Question 1: Delete the reference datum C?

Question 2: Smaller profile tolerance value?

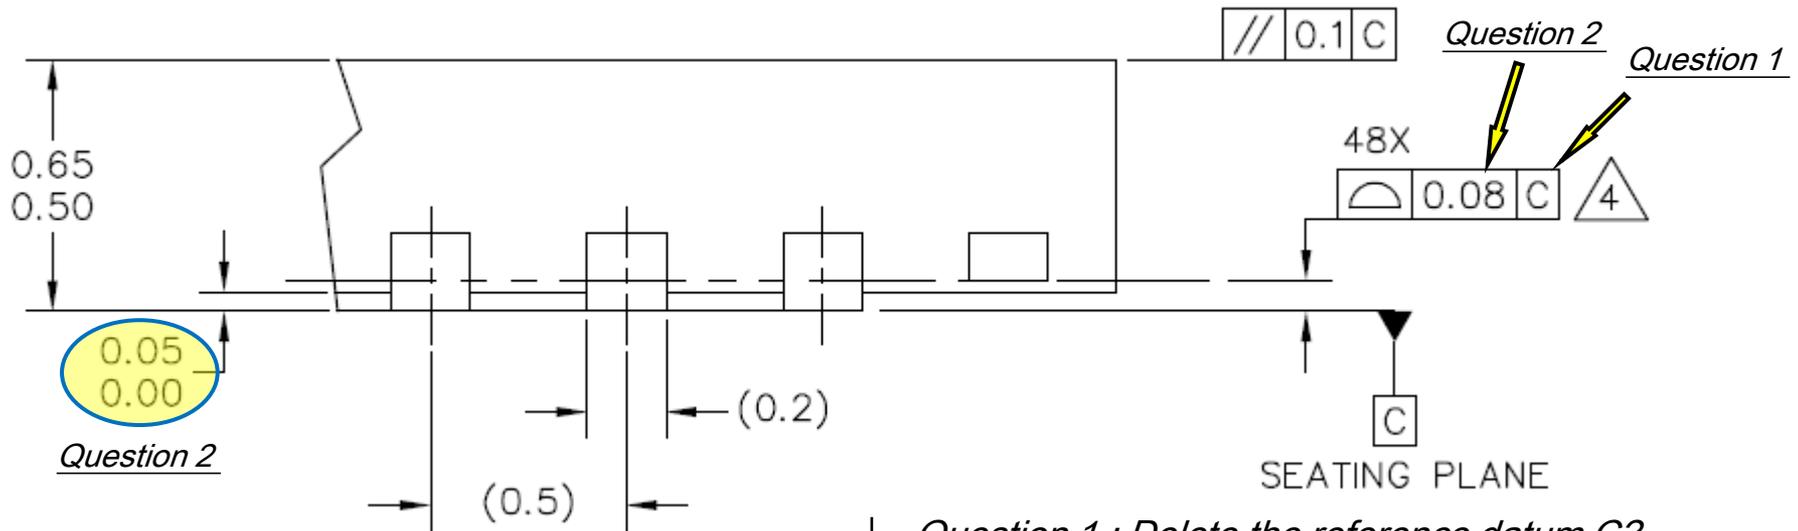
Question 2

Question 1

The 48 lead surfaces and the exposed die pad are designated as datum features C, they are referred to as coplanar datum features, so the profile callout will not contain datum feature references and I will delete the referenced datum C from the profile callout FCF. Besides, when a profile tolerance is specified without any datum feature to control coplanarity, the tolerance zone is unilateral, so I will delete the phantom lines to make the drawing clean and neat.

Since the profile tolerance zone is unilateral, but the max lead height is only 0.05, and the profile tolerance value 0.08 is larger than the size tolerance 0.05, that means it will allow 0.03(0.08-0.05) below the surface, that is impractical so I believe the profile tolerance value should be less than the size tolerance, how do you think of it?
